Rear Seat-Back Lock Is Hard to Turn

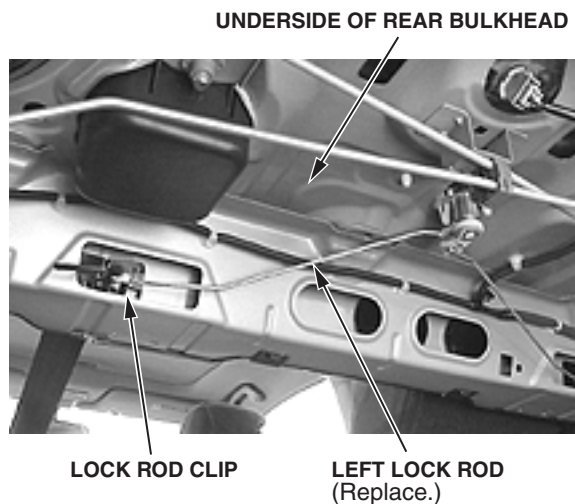
The rear seat-back lock is hard to turn, or it won't turn at all.

The left lock rod is too long.

Replace the lock rod.

Lock Rod: P/N 82620-S5P-999, H/C 6597660

1. Open the trunk.
2. Pull the left rear seat handle to release the seat-back.
3. Rotate the lock rod clip; remove and discard the lock rod.

4. Install the new lock rod.
5. Reinstall the lock rod clip.
6. Lock and unlock the seat-back three or four times to make sure the lock works well.
